# Access Compliance Report

### (Curb Ramps)

Intersection ID: 10041752	Main Street: WILKINSON_BV	Cross Street: N/A	Location:	N
ADA ID: D4373025E27C	Ramp Type: Perp	Initial Pass/Fail: Fail	Overall Compliance: No	Severity Score: 10
Codes/Mitigation Info/Possible Solution		Field Measurements/Component Compliance

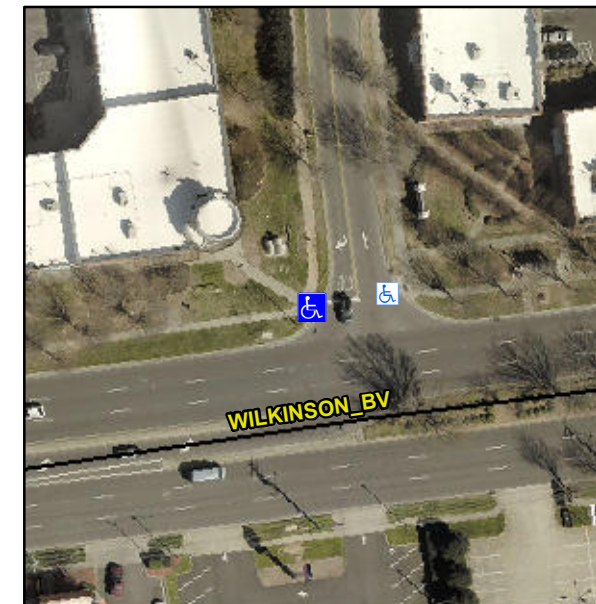
**R304.5.1, R304.5.3**

Compliance	Description	Data	Compliance	Description	Data
N/A	Ramp Length (in)	124.0	Yes	Ramp Slope (%)	7.9
No	Ramp Width (in)	47.0	No	Ramp XSlope (%)	2.6
N/A	Flare Type LT	N/A	N/A	Flare Type RT	N/A
N/A	Flare Slope LT (%)	N/A	N/A	Flare Slope RT (%)	N/A
N/A	Flare Traversable LT?	N/A	N/A	Flare Traversable RT?	N/A
N/A	Landing Length (in)	N/A	N/A	DWS Provided?	N/A
N/A	Landing Width (in)	N/A	N/A	DWS Contrast?	N/A
N/A	Landing Slope (%)	N/A	N/A	DWS Length (in)	N/A
N/A	Landing X Slope (%)	N/A	N/A	DWS Full Width?	N/A
N/A	Landing Curb? (Y/N)	N/A	N/A	DWS Offset (in)	N/A
N/A	Shared Landing?	N/A			
N/A	Gutter Ponding?	N/A	N/A	Gutter Slope (%)	N/A
N/A	Gutter Lip Ht (in)	N/A	N/A	Gutter X Slope (%)	N/A
N/A	Painted X Walk1?	No	N/A	Painted X Walk2?	N/A
	X Walk 1 Direction	To E		X Walk 2 Direction	N/A
N/A	X Walk 1 Width (in)	N/A	N/A	X Walk 2 Width (in)	N/A
	X Walk 1 Slope (%)	6.2		X Walk 2 Slope (%)	N/A
	X Walk 1 X Slope (%)	1.1		X Walk 2 X Slope (%)	N/A

**Remove & Replace Entire Ramp.**
